LIGO Laboratory

Date:	<u>7 May</u> 2008	Refer to:	<u>L080047-01</u>
Subject:	Response to Systems PDR committee comments and questions regarding the Optical Layout and Generic Subsystem Requirements		
To:	Advanced LIGO Systems PDR committee		
From:	Peter Fritschel, Dennis Coyne

Optical Layout, T010076-02

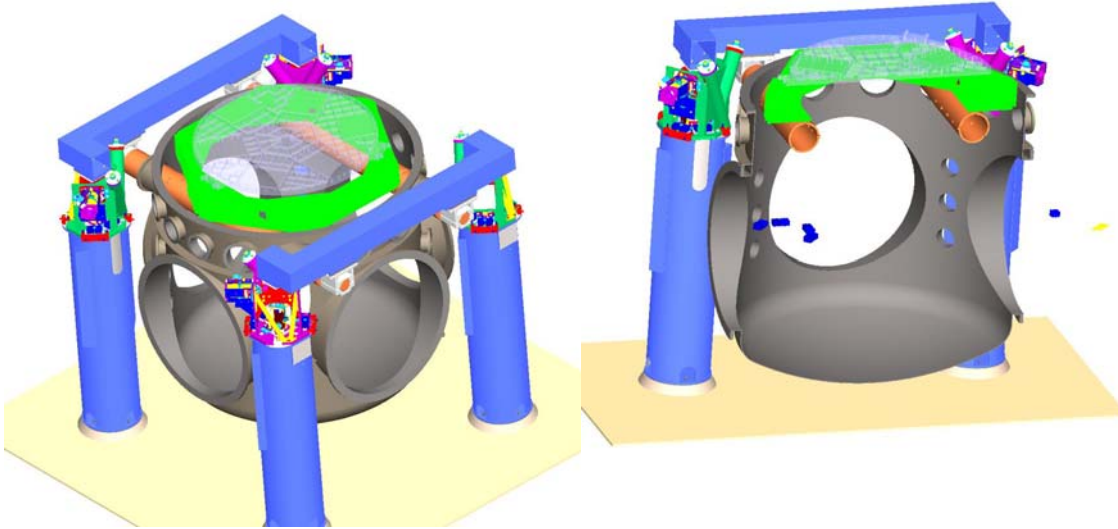
11. Table 2: HSTS and HLTS are not defined in the document, as least as far as I can tell. In any event an acronym listing (as an appendix) would be a good idea.

They are defined in Table 1. Nonetheless the suggestion is valid.

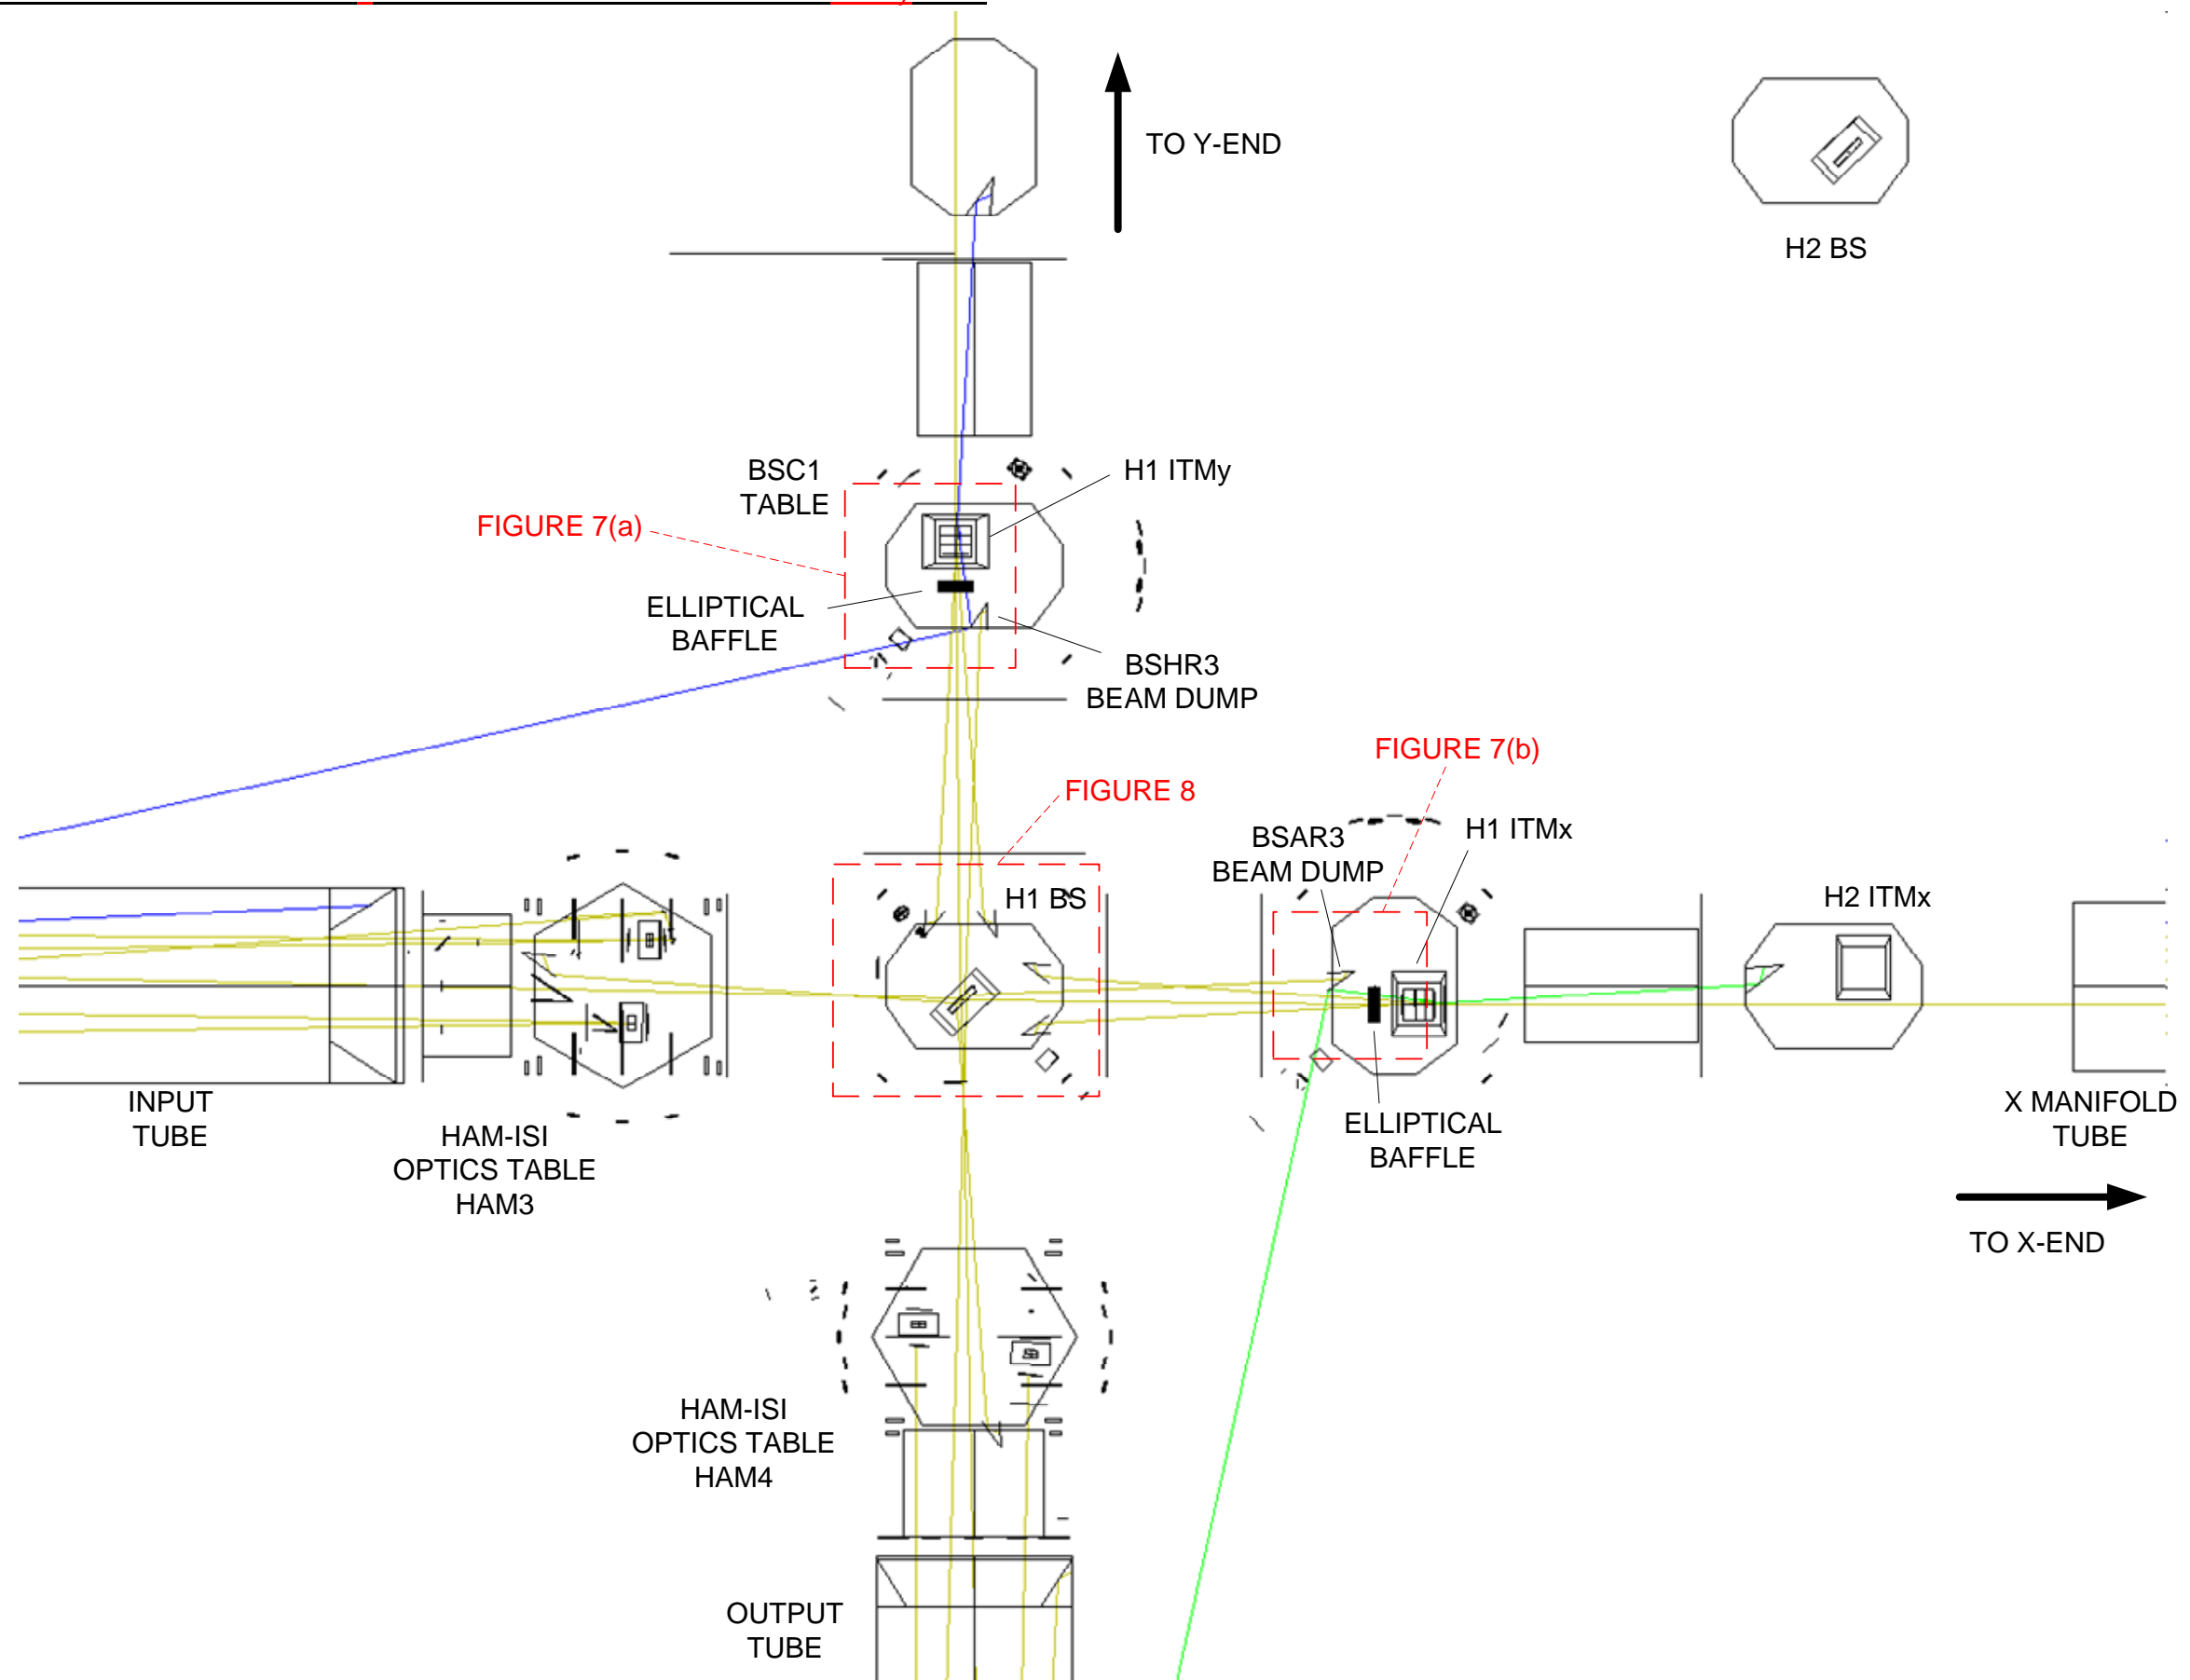
13. Section 5.6 made no sense to me.

I can only guess that it is the second paragraph that is unclear. I suspect that the following images with a transparent BSC optics table in elevation makes clear the fact that the table limits are “hard limits” determined by the support tubes (orange) and the stage-0 support ring (green).
